Metropolitan Development Commission Regional Center Hearing Examiner (September 24, 2026) Meeting Agenda

REGIONAL CENTER HEARING EXAMINER – HIGH IMPACT CASE

Case Number	2026-REG-006
Address (approx.)	219 Koehne Street, 1437 – 1533 (odd) Saulcy Street, and 1422 – 1528 (even) Astor Street
Location	Center Township, Council District #18
Petitioner	Union Holdings III, LLC, by Misha Rabinowitch
Zoning	D-8 (RC)
Request	Regional Center Approval to provide for demolition of existing dwellings and accessory structures and for construction of a multi-family residential development, consisting of approximately 242 units, an integrated parking garage with 258 spaces, and resident amenities, including a community room, a playground, dog park, and grilling area.

Floor Plans

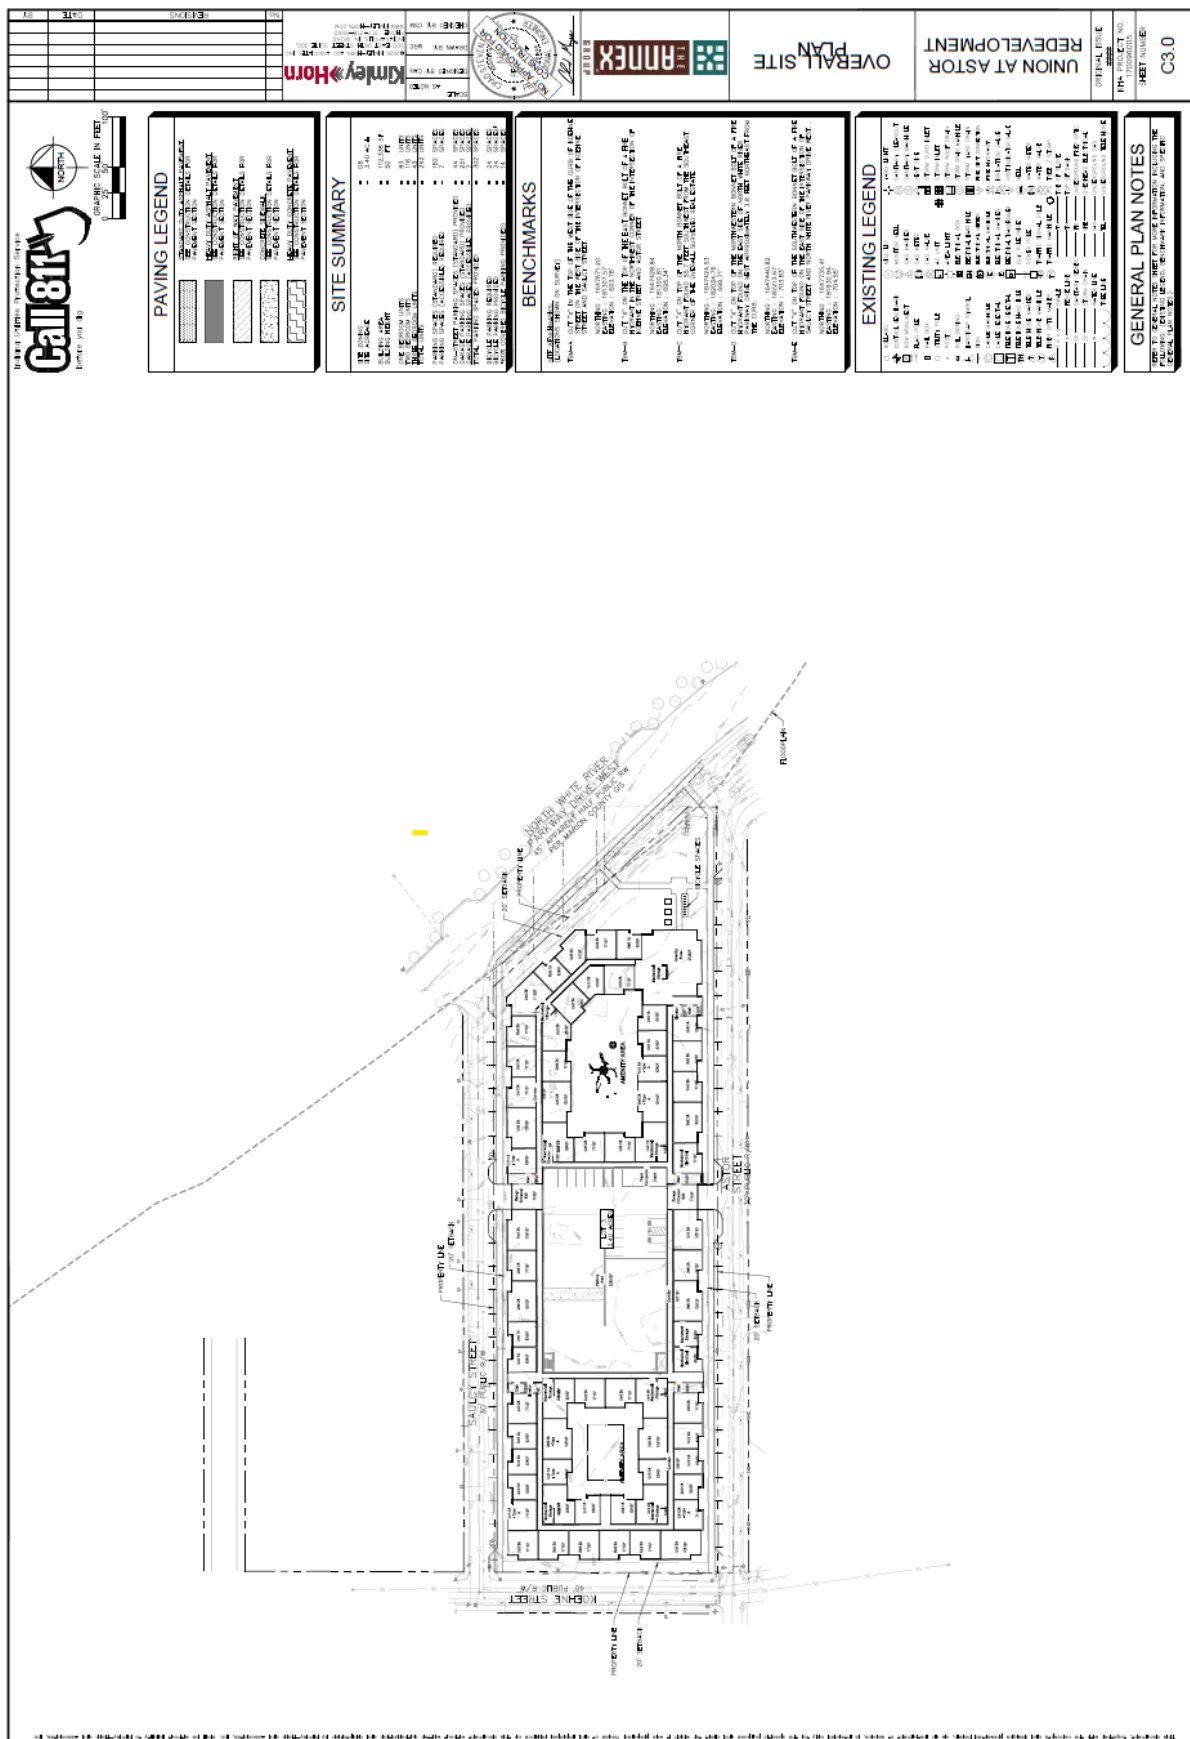
This petition was automatically continued from the August 27, 2026, Regional Center Hearing Examiner (as acknowledged by the Regional Hearing Examiner at the September 10, 2026, hearing). On September 10, 2026, revised floor plans, site plans and landscape plans were submitted. The updated plans include bike parking, gabled roof areas for the western section of
